A G E N D A
FARRAGUT MUNICIPAL PLANNING COMMISSION

April 21, 2016
7:00 p.m. Farragut Town Hall

SUBJECT: Discussion and public hearing on a site plan for O'Reilly Auto Parts, Parcel 36, Group B, Tax Map 143G, Zoned C-1, located at 10870 Kingston Pike, 1.04 Acres (Thornton Drive, LLC, Applicant)

Re: Staff comments on site plan for O'Reilly Auto Parts, 10870 Kingston Pike

SHEET NUMBER: **SP1**

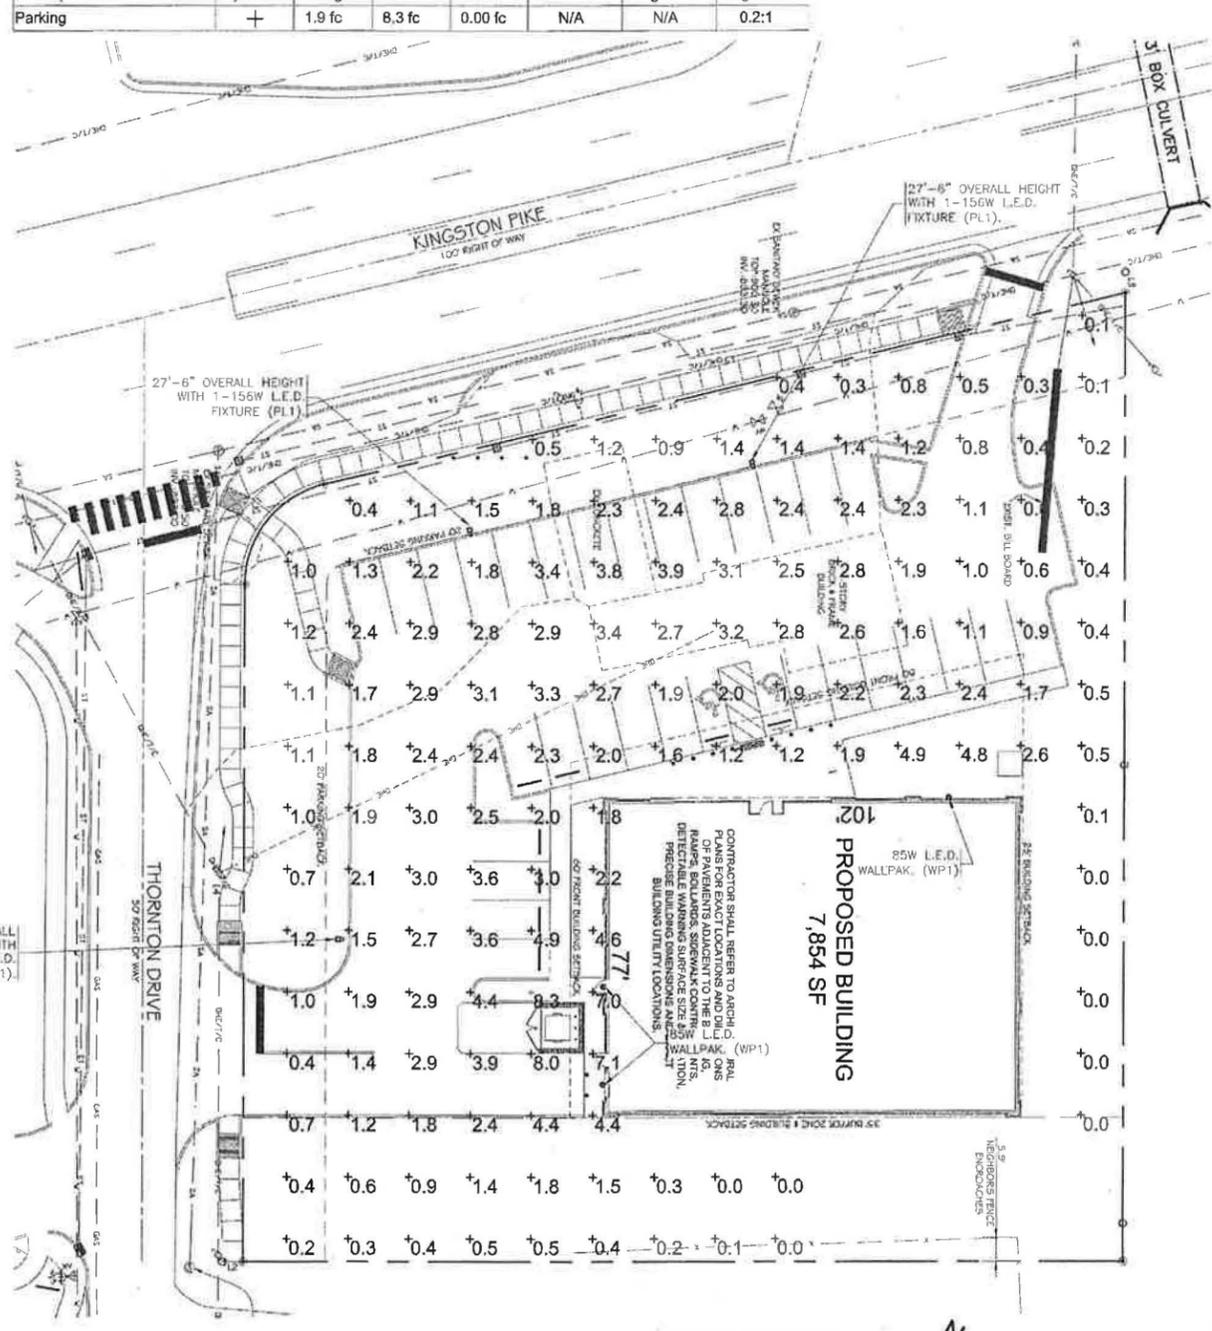
19. Please correct the quantities in the light fixture table to reflect the number that is being provided.
The table has been revised to show the correct quantities. See sheet SP1.

20. One of the foot-candles along the south property line exceeds the .5 that is permitted. Please correct.

Photometrics have been revised. See sheet SP1.

Cross section of the light pole has been added. See sheet SP1.

SHEET 17 OF 20

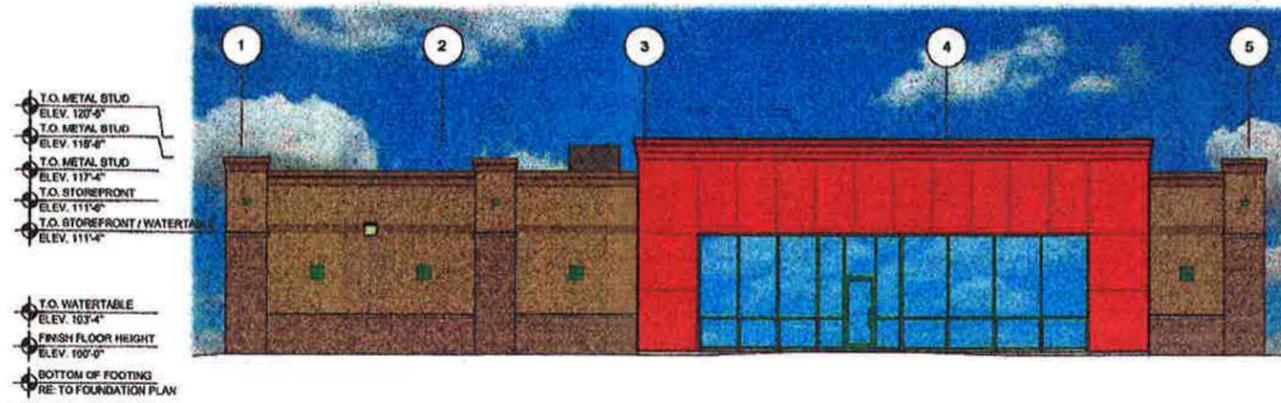
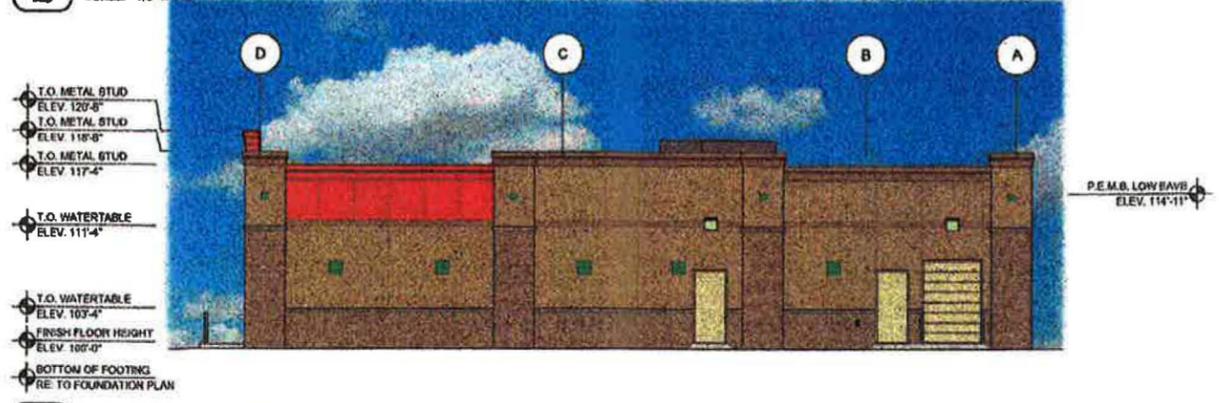
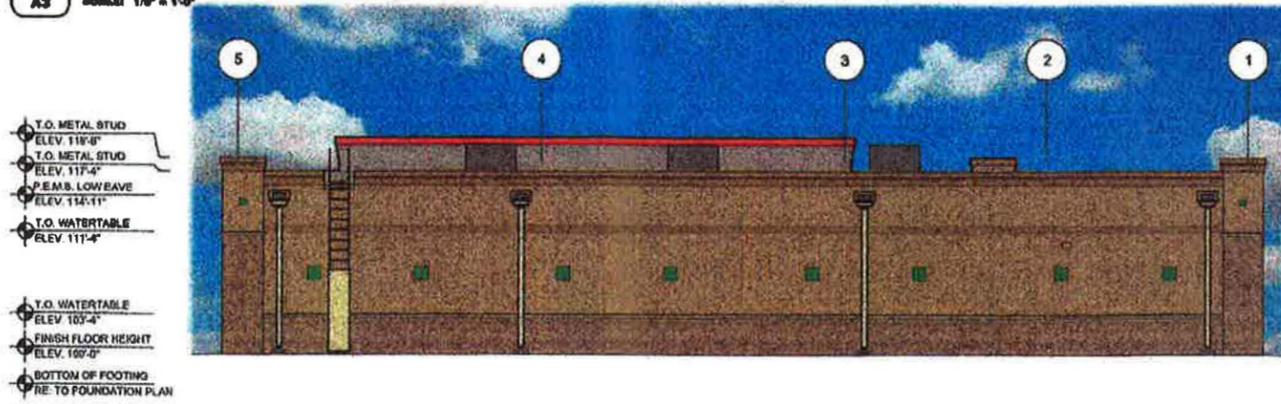
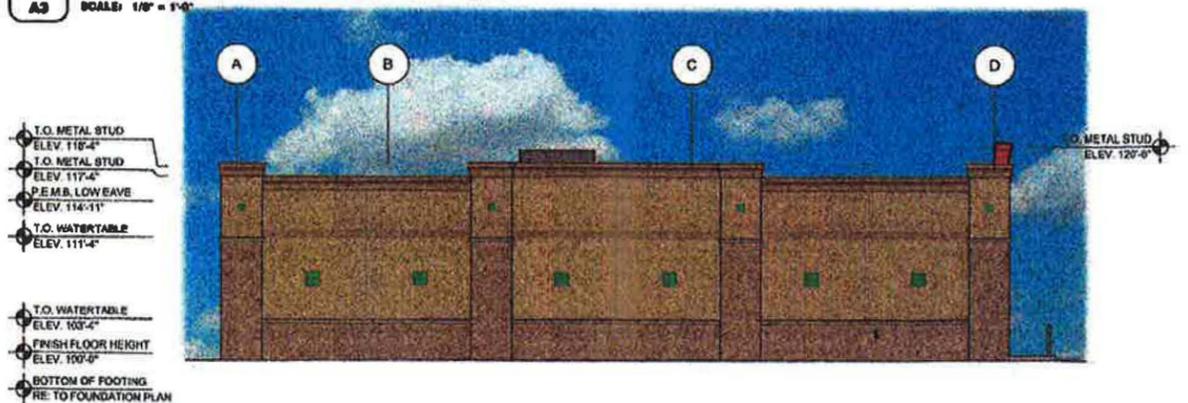
11. Please include a color rendering of all elevations of the building and verify, consistent with Standard 2.17 of the ADS, that the net façade area contains at least 60% masonry material (brick and/or stone). Masonry should be concentrated on the more visible elevations.
We provided an 11x17 color rendering of all elevations and a 24x36 in black and white which show the calculations for net area of masonry material. If my understanding from staff that the red EFIS would not be permitted. The architect will need to get approval from the tenant for a change in color to a more muted "earth tone". We expect to receive a revised color rendering in the next few days and will submit to you. See sheets A3 and A3.A.

22. Sheet 17 shows that the HVAC units are visible on the roof. Please extend the parapet height so that they are not visible on the roof.

We feel a bold and defined entrance has been provided through our use of the red EFIS portal. We feel the color and material change, as well as the solid row of storefront glass within the legs of the portal, all create a bold statement that designates the entry point. See sheets A3 and A3.A

The line of site drawing illustrates that with the current parapet heights, the RTU's will not be visible from ground level at the property lines on each side of the building. Upon further discussion with Town staff, we will reevaluate to be assured all of the roof top units will be screened by the parapets. See sheet A3.B.
